Notes on the design of the FAST proton LEBT

A. Shemyakin, J.–P. Carneiro

3 March 2020

Version 2

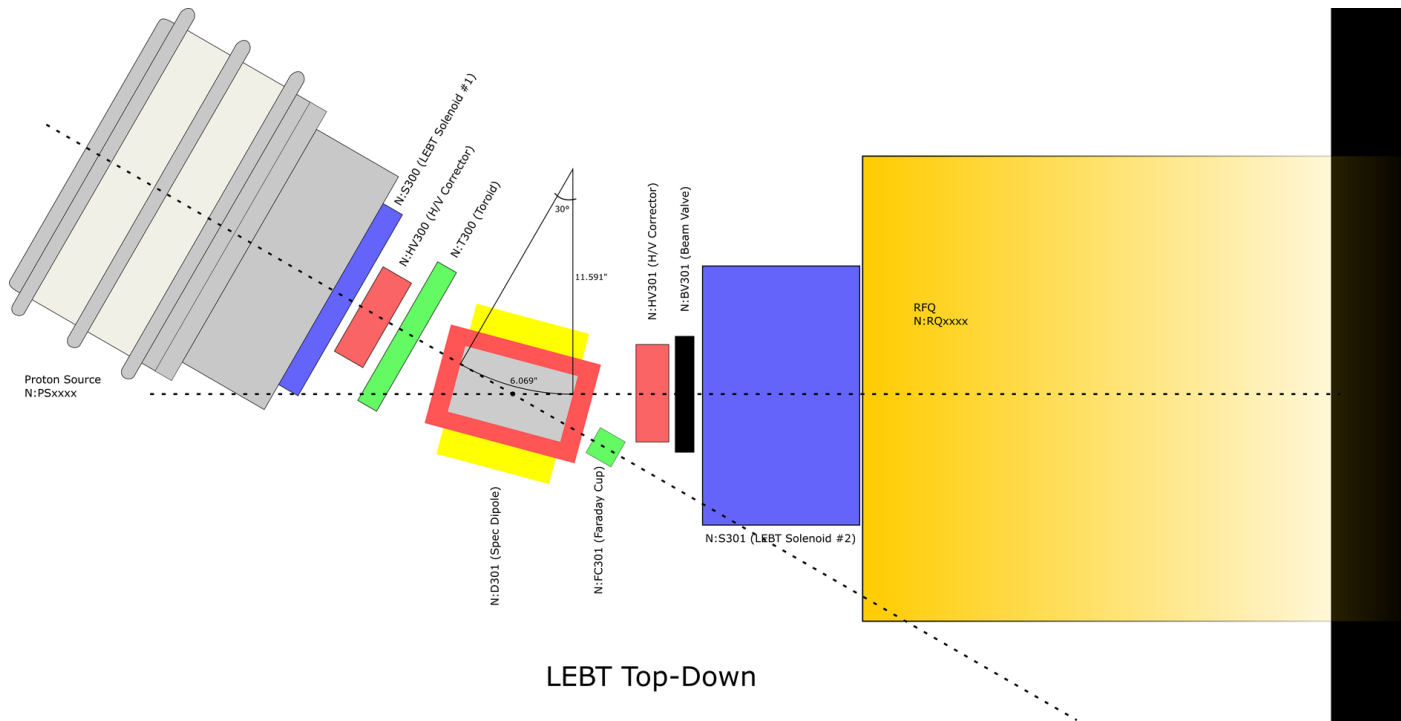
- Chip's suggestion to install a bend
 - As a critical device
 - To remove early H2+, H3+

Version 3

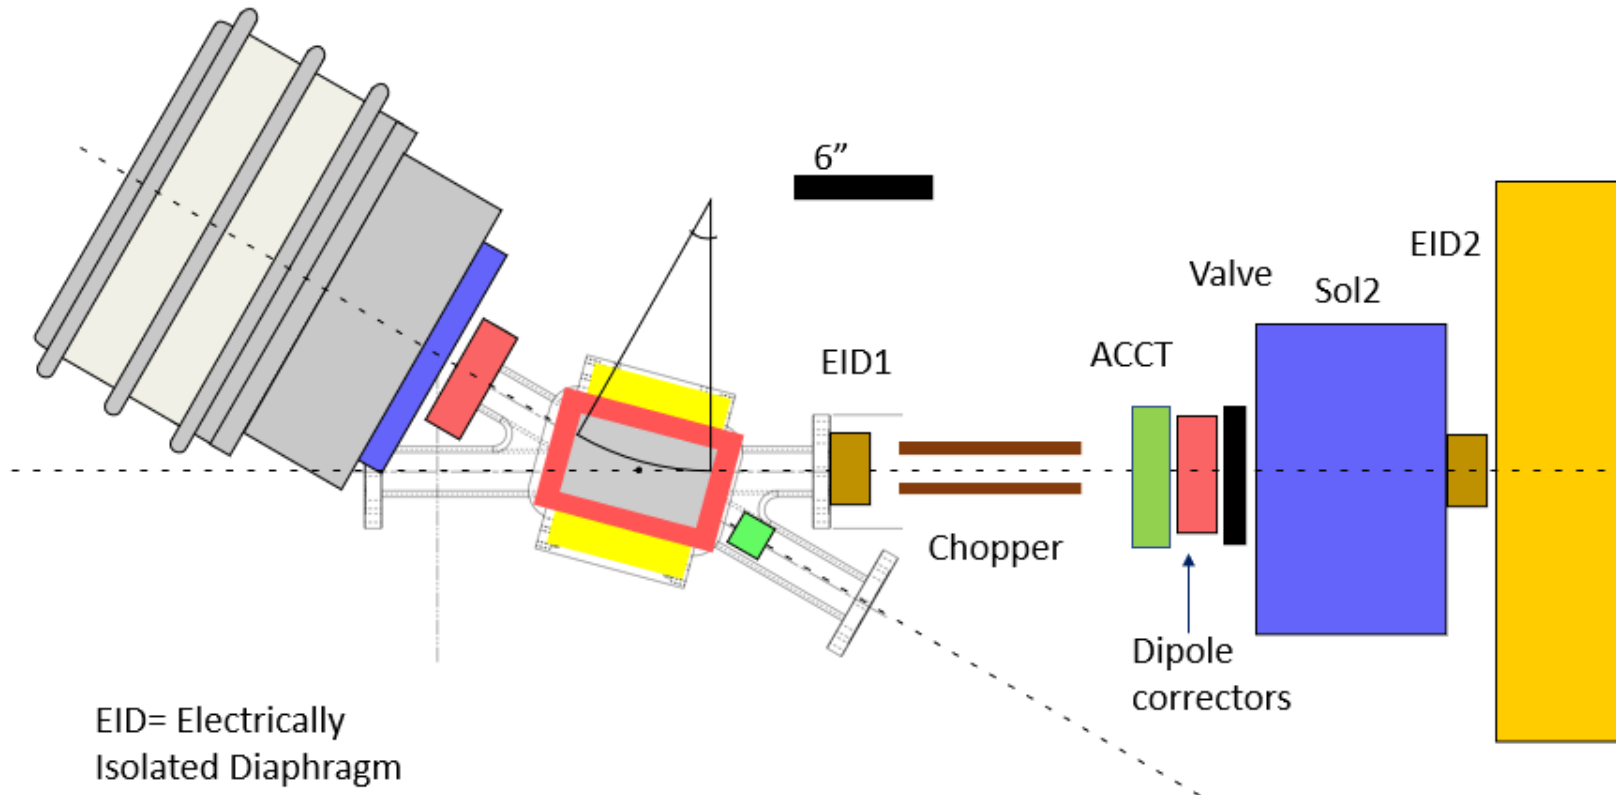
- Chopper to define the pulse length and EIDs to control neutralization, similar to PIP2IT LEBT
 - Design of the chopper and EID may be based on PIP2IT's

Rms envelope. J.-P. Carneiro, TRAC. The upstream portion (~65 cm) is with zero space charge, and 22 mA in the downstream portion. The initial distribution is Water Bag.

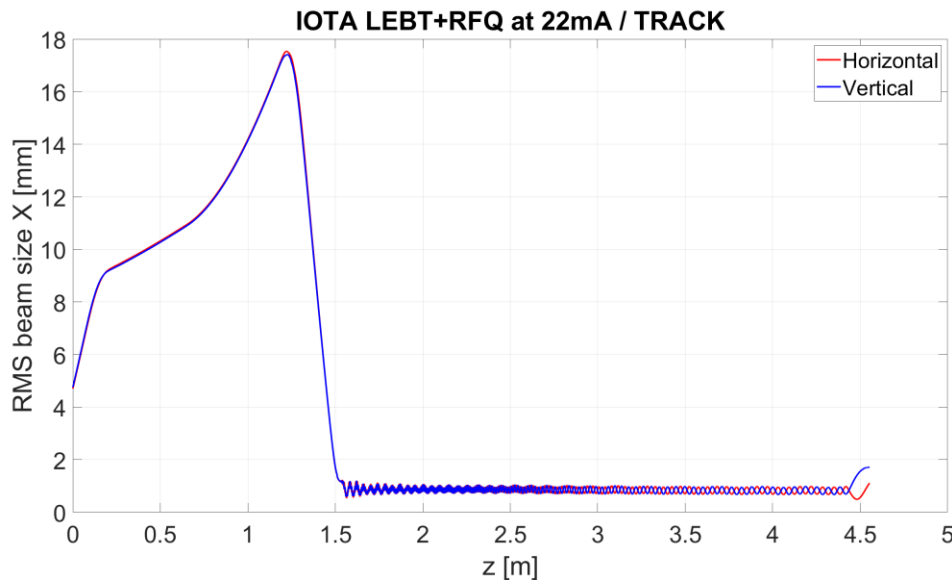
- J.-P. Carneiro, TRAC, 21-Feb-2020
 - Initial conditions are the same as P. Ostroumov used for HINS simulations
 - $\epsilon_{\text{rms}_n} = 0.47 \mu\text{m}$, $I = 22 \text{ mA}$ (the worst scenario)
 - For this longer LEBT, no solution for transport with full space charge
 - With upstream portion neutralized, the beam is still large

- Beam size is too large to have a chopper
 - No easy solution to make a chopper without significant scraping ($U=10$ kV, $L=150$ mm). Note that relative separation between envelopes of the beam passed and beam removed is $\sim 1/\epsilon_{rms}$
- Difficult to pass through the existing dipole magnet (2" gap).
- No proper matching into the RFQ
 - 50% of the beam is lost at the entrance diaphragm (10 mm ID)
- Reasons for troubles:
 - Increased distance between RFQ and center of Sol 2
 - High space charge from 22 mA
 - Very high initial emittance
 - Unknown initial distribution
- While in reality the beam parameters might be more favorable, it feels too risky to proceed with this version

Rms and full envelopes for WB initial distribution. J.-P. Carneiro, TRAC. No space charge.
 $\epsilon_{rms_n}=0.47 \mu\text{m}$.

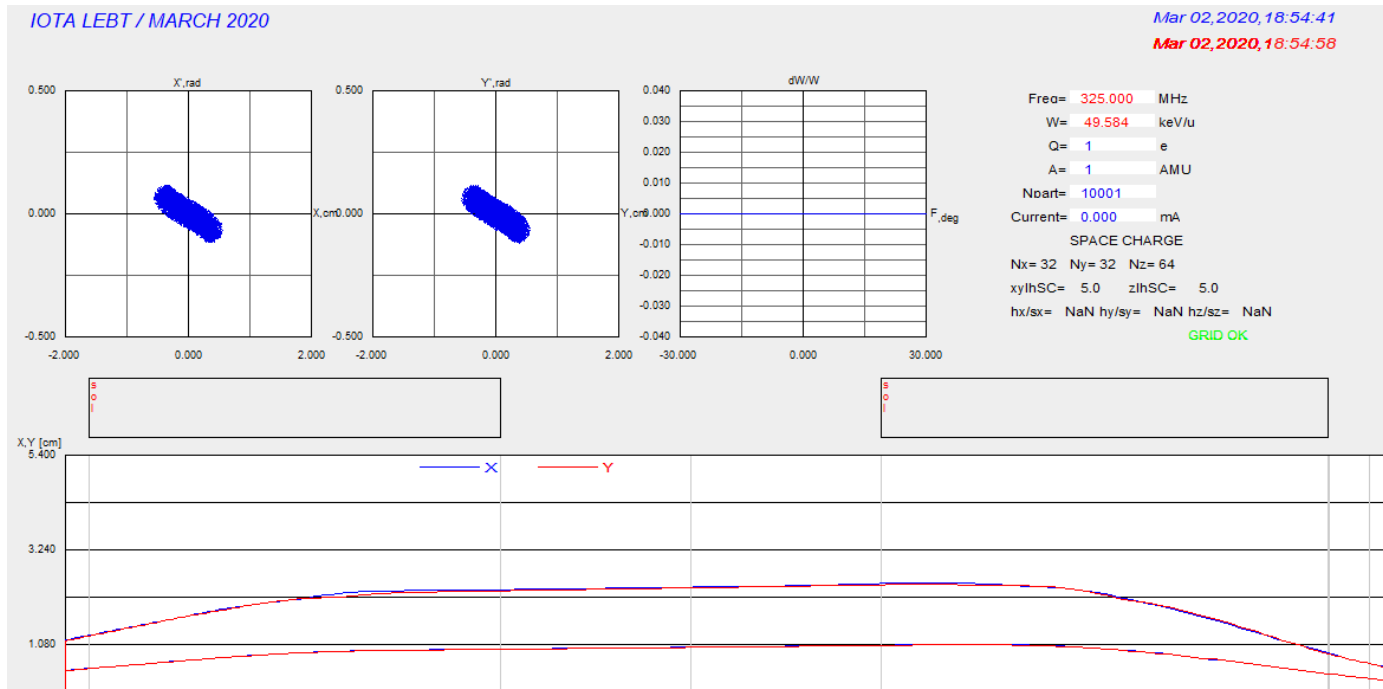
- In the “HINS” version, assuming full neutralization, the beam looks reasonable
 - A big uncertainty with initial conditions and possible degree of neutralization
 - Predicts scraping already in the first solenoid

Possible timing

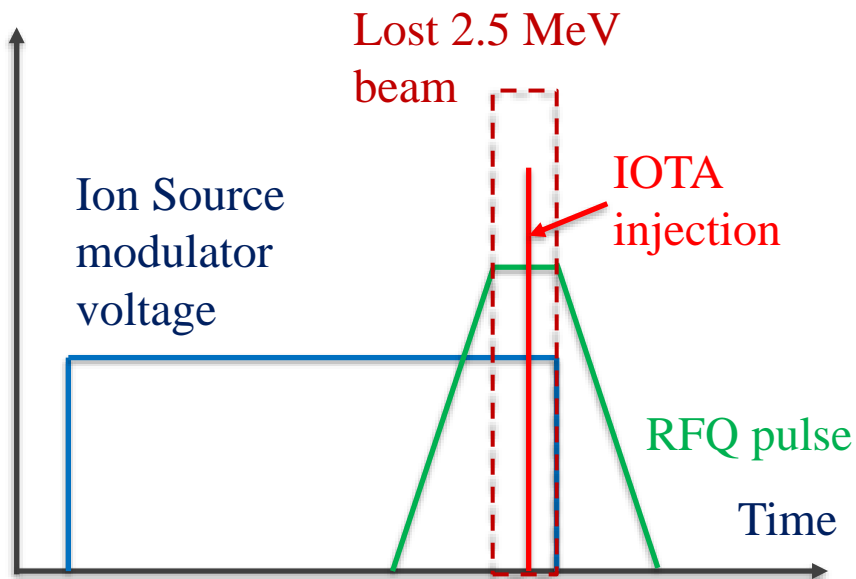
- The issue of a possible thermal stress may be alleviated by shifting the RFQ pulse with respect to IS's
 - Its duration can be likely decreased to $<50 \mu\text{s}$
 - In Vic's talk, $\sim 30 \mu\text{s}$ seems to be enough for parameters to settle
 - Slide 19
